USB Type-C ENGINEERING CHANGE NOTICE

Title: Correction for Attached.SNK

**Applied to: USB Type-C Specification Release 1.2 Draft,
December, 2015**

(a). Figure B-5

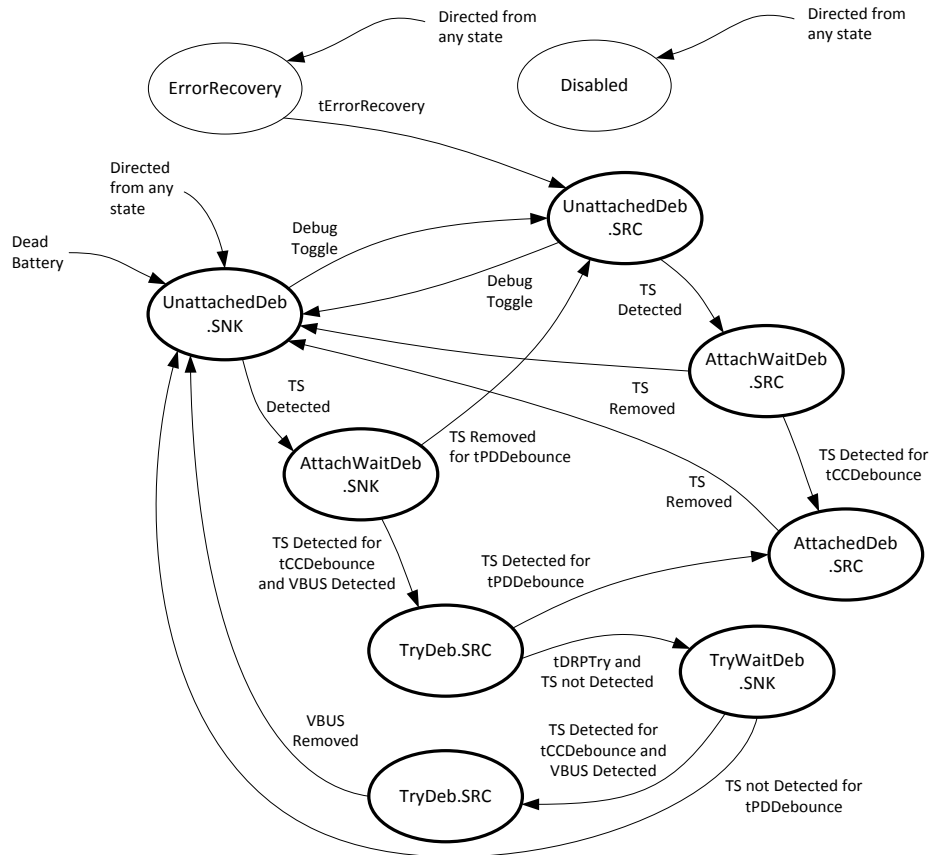
Figure B-5 incorrectly labels AttachedDeb.SNK as TryDeb.SRC (exit path from TryWaitDeb.SNK). Correcting figure

Corrects flow to match text and avoid confusion
